Access Compliance Report

| Intersection ID: 46951 | Main Street: PROVIDENCE_RD | Cross Street: OLDE_WHITE_LN | Location: SW |
| ADA ID: 6899C9D393B2 | Ramp Type: Combination1 | Initial Pass/Fail: Fail | Overall Compliance: No |

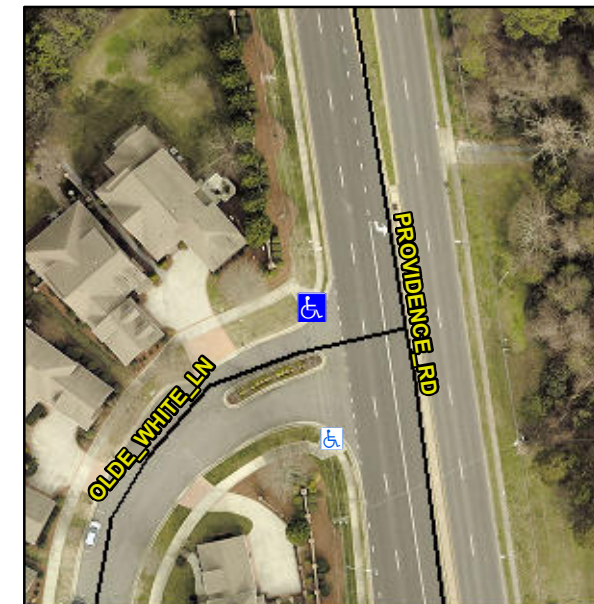
Possible Solutions:

**Remove & Replace Entire Ramp.
Remove & Replace Sidewalk.**

Surveyor Notes:

LT RP < 5%

PROW/ADA:

R304.5.1, R304.5.3
